HAPPY VALLEY INTERIM MEASURES WORK PLAN ADDENDUM AMENDMENT
HAPPY VALLEY AND BUILDING 359 AREAS OF CONCERN
SANTA SUSANA FIELD LABORATORY
VENTURA COUNTY, CALIFORNIA

August 2003

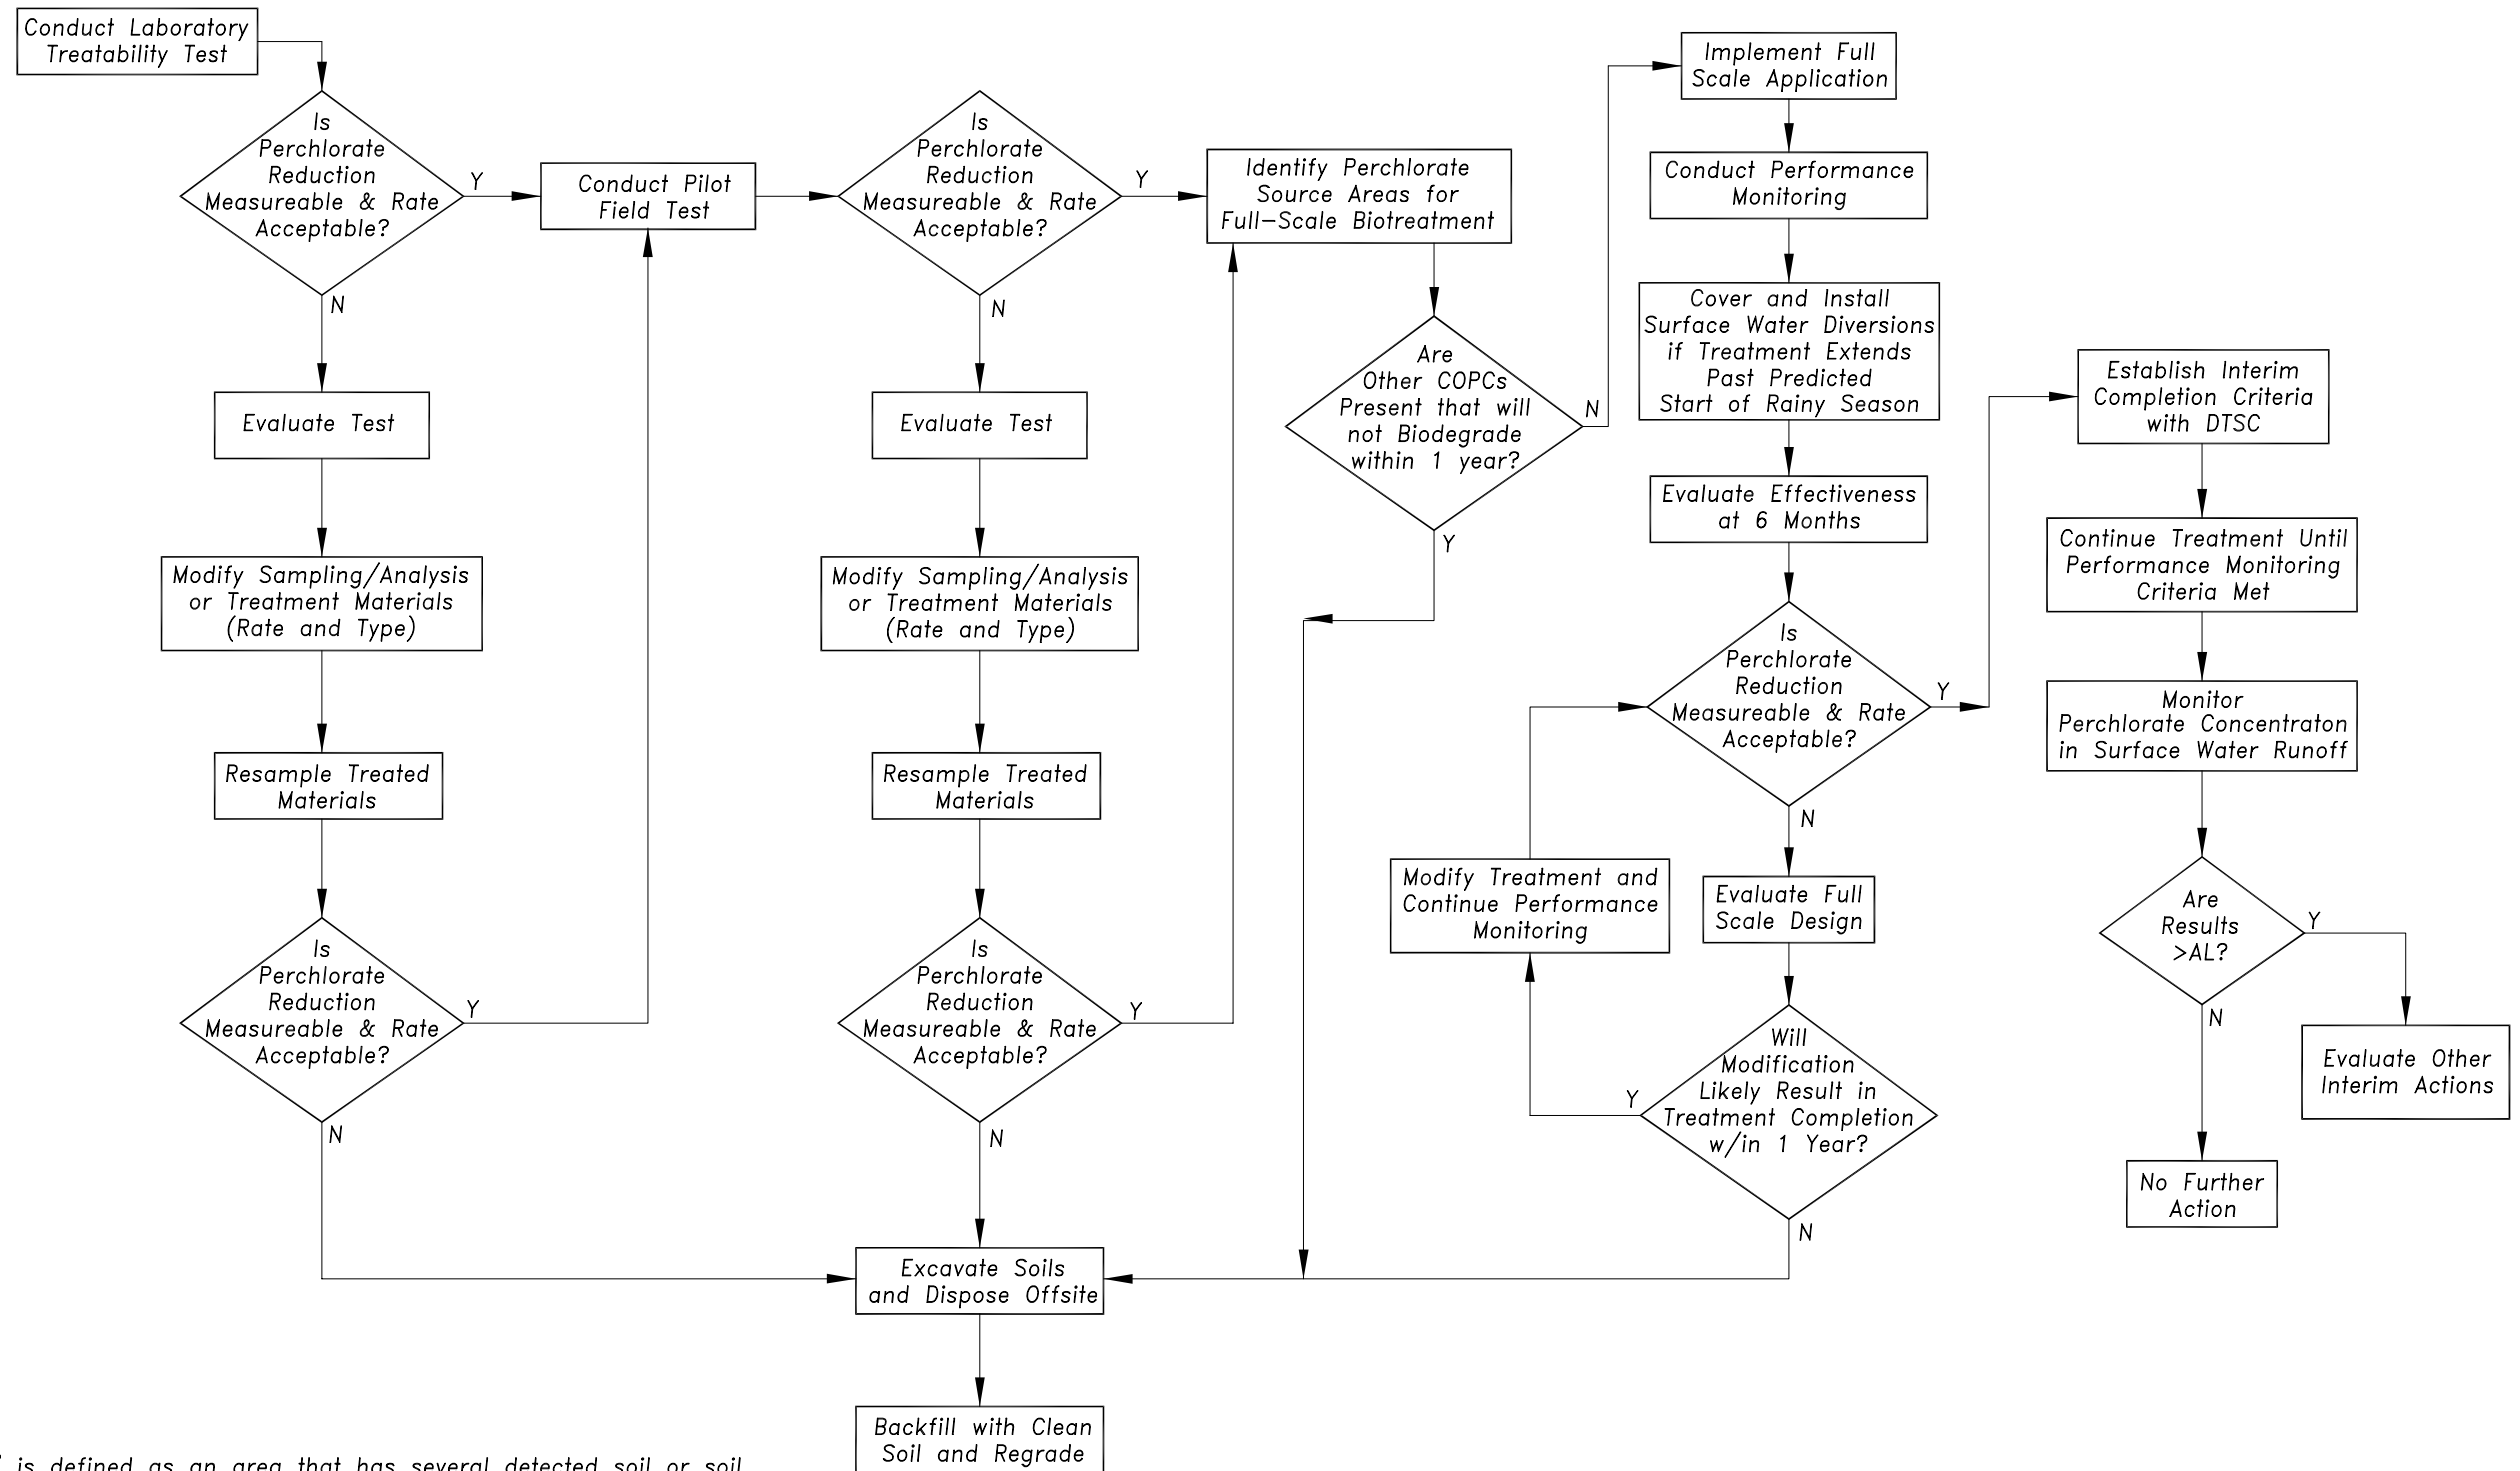
4. Subsection 3.2, Table 3, and Figure 4 of the HVIM Amendment provide details on the simulated rainfall event sampling process. The intent is not to flood the drainage or cause significant runoff. The sampling is intended to provide a “field screening” of potential perchlorate concentrations in drainage surface water in isolated portions of the Happy Valley drainage.
5. Appropriate controls will be implemented to minimize runoff. Some controls will be designed for a 25-year, 24-hour storm event, although it is not anticipated, based on historical conditions in Happy Valley. These controls are presented in Subsections 3.1 and 3.3 of the HVIM Amendment.
6. Boeing will use the RWQCB’s May 1996 *Interim Site Assessment and Cleanup Guidebook*, as appropriate, to evaluate potential backfill materials. Subsection 3.1 of the HVIM Amendment details potential backfill procedures.

Figure 7 - HVIM Amendment
Proposed Interim Measures for
Perchlorate Near Former Building
Foundations Within the Happy Valley
and Bldg 359 Areas
MWH August 2003

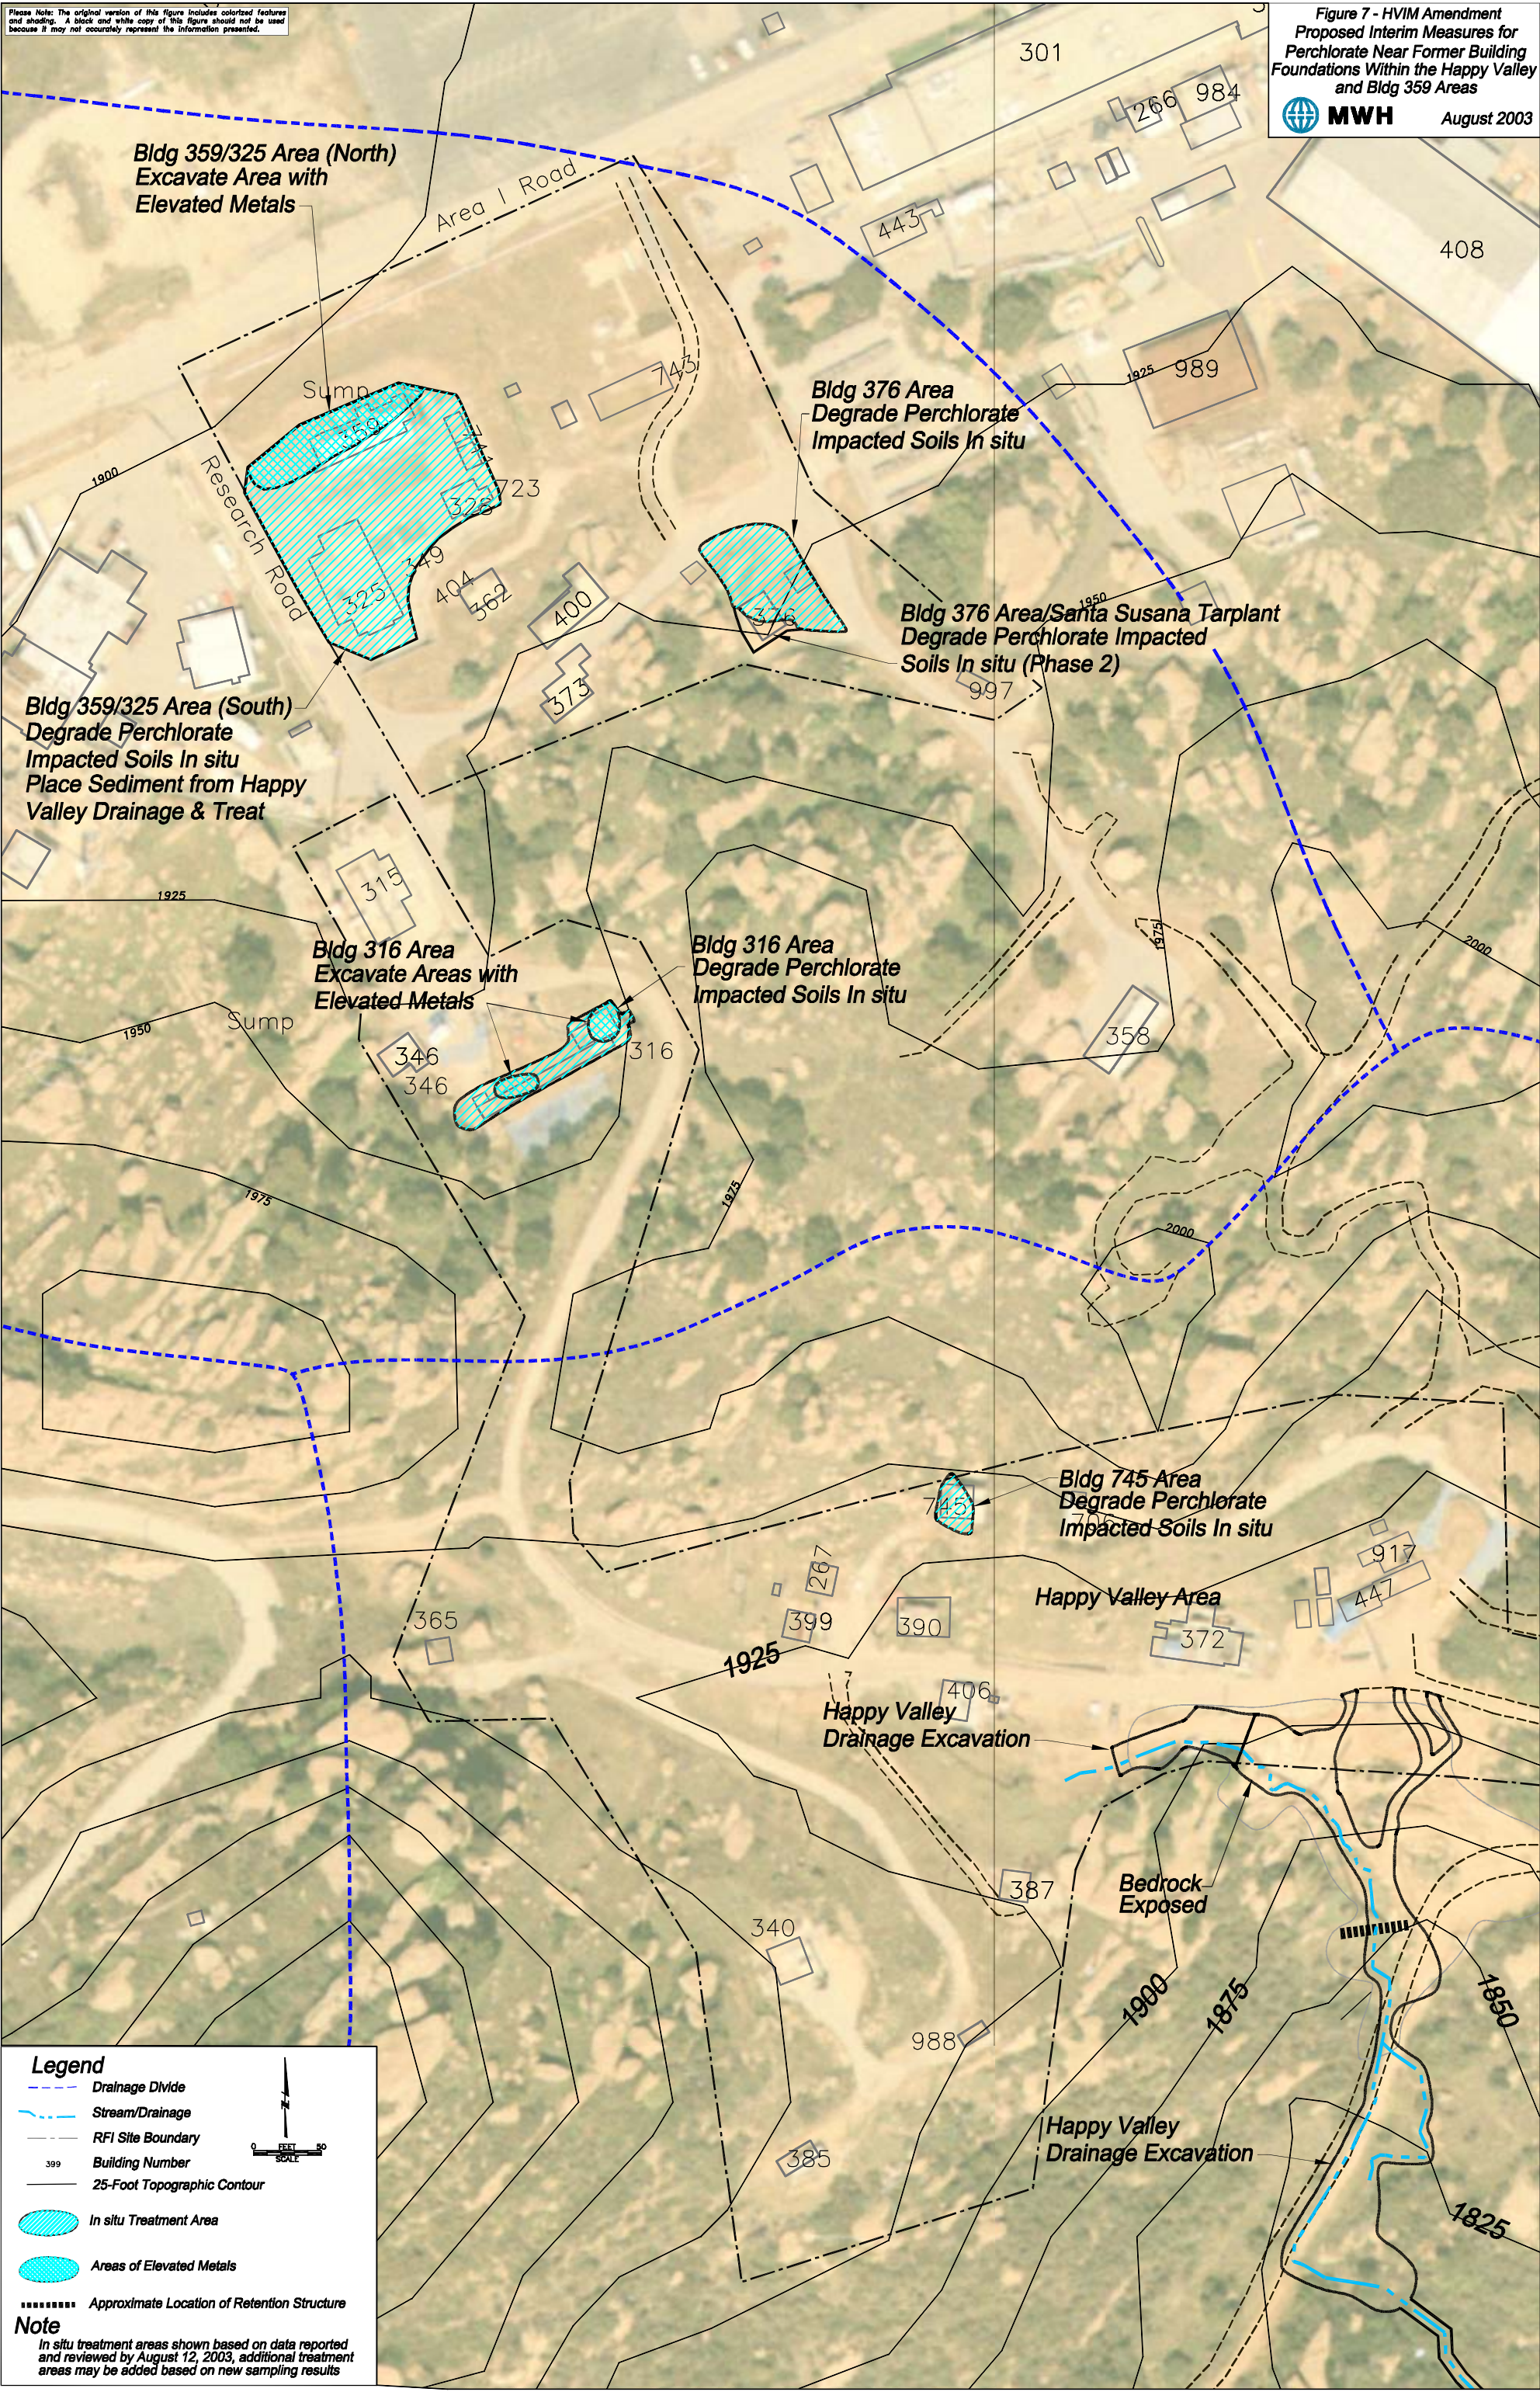
11. Samples have been analyzed for constituents other than perchlorate. Section 4.0 discusses COPCs detected and Figure 7 identifies their locations in areas identified for perchlorate *in situ* treatment. COPCs that occur in perchlorate-impacted areas are being addressed in the HVIM Amendment.
12. The HVIM Amendment specifically addresses those areas where Santa Susana Tarplant can be avoided. As these areas will be mitigated prior to the winter 2003/2004 rainy season. In areas where Santa Susana Tarplant cannot be avoided, special permitting will be required. Phase II of the HVIM will be conducted after the special permit is obtained (the permit may require up to 9 months to obtain). Section 1, Page 3 addresses the phasing of work.
